HADDAM NECK PLANT

PROPOSED CHANGES TO TECHNICAL SPECIFICATIONS

JULY, 1980

Figure 6.2-1

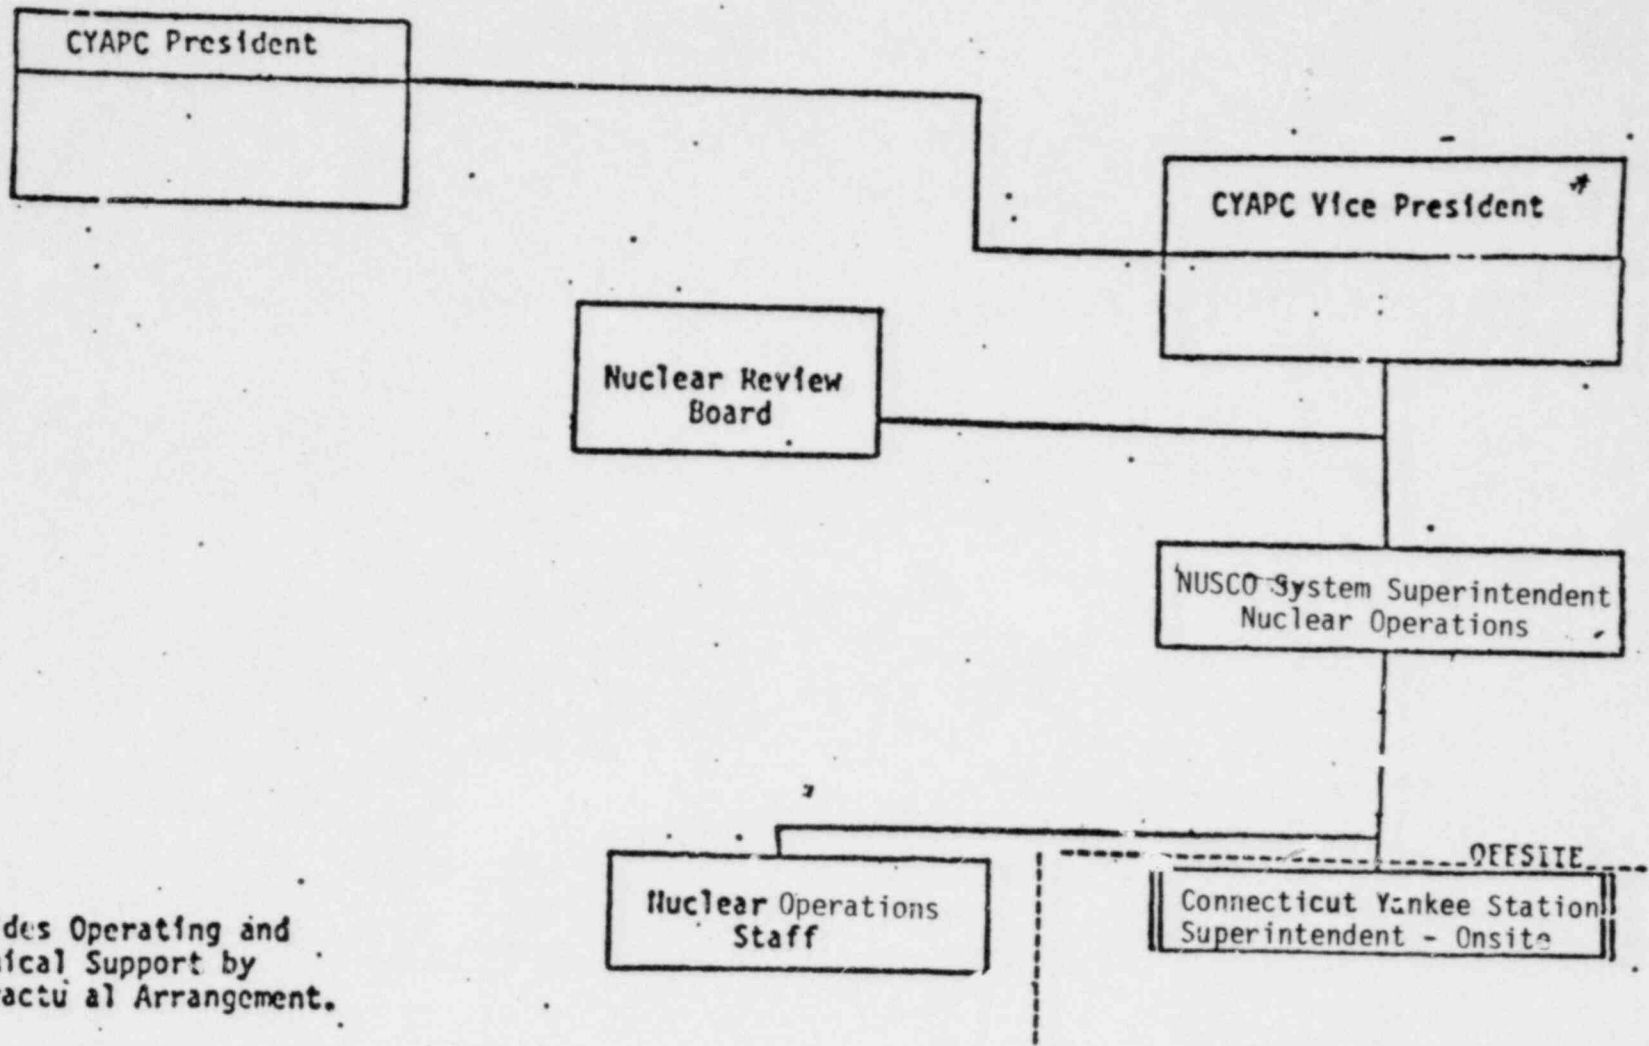
6.2.1 The offsite organization for facility management and technical support shall be as shown on Figure 6.2.1.

* Also NUSCO Senior Vice President Nuclear Engineering and Operations
